# Agenda Report

September 24, 2018

**TO:** Honorable Mayor and City Council  
**FROM:** Planning & Community Development Department  
**SUBJECT: PREDEVELOPMENT PLAN REVIEW OF A MIXED-USE DEVELOPMENT PROPOSED AT 83 N. LAKE AVENUE**

**Figure 4: Central District Housing Areas**

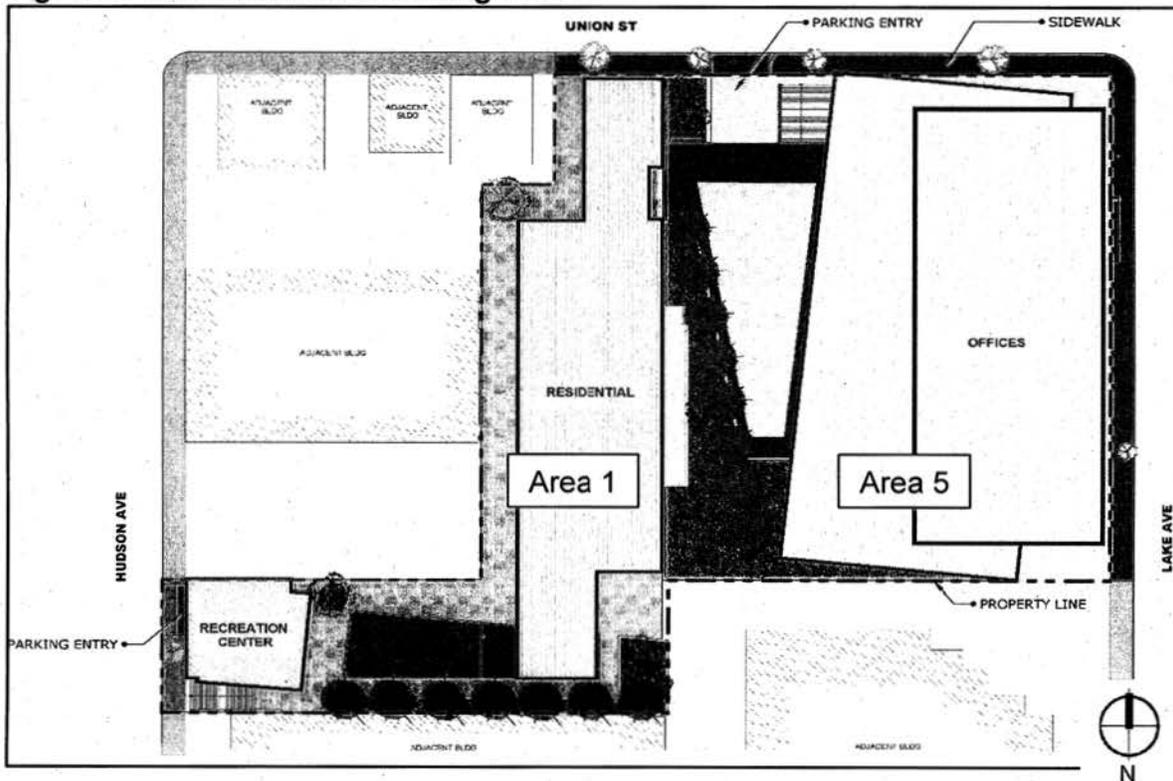
The project site is divided into two separate Central District Housing areas (Area 1 and 5) that establish different limitations for residential units. Area 1 (western half), with frontage along Hudson Avenue and portions of Union Street, allows housing without limitation. Area 5 (eastern half), with frontage along Lake Avenue and portions of Union Street, is restricted to nonresidential uses. Specifically, a minimum of 50 percent of the ground floor street frontage along Lake Avenue is required to consist of pedestrian-oriented uses. The remaining 50 percent may contain uses otherwise permitted and/or accommodate pedestrian and vehicular access. Retail and restaurants are examples of pedestrian-oriented uses. Office does not qualify as a pedestrian-oriented use. The applicant has proposed a six-story office tower along Lake Avenue. Pedestrian-oriented uses are not included at the ground floor street frontage along Lake Avenue. This is incompatible with the requirements of the Central District Specific Plan. However, all housing proposed is within a six-story residential tower located in Area 1. No housing is proposed within Area 5, which complies
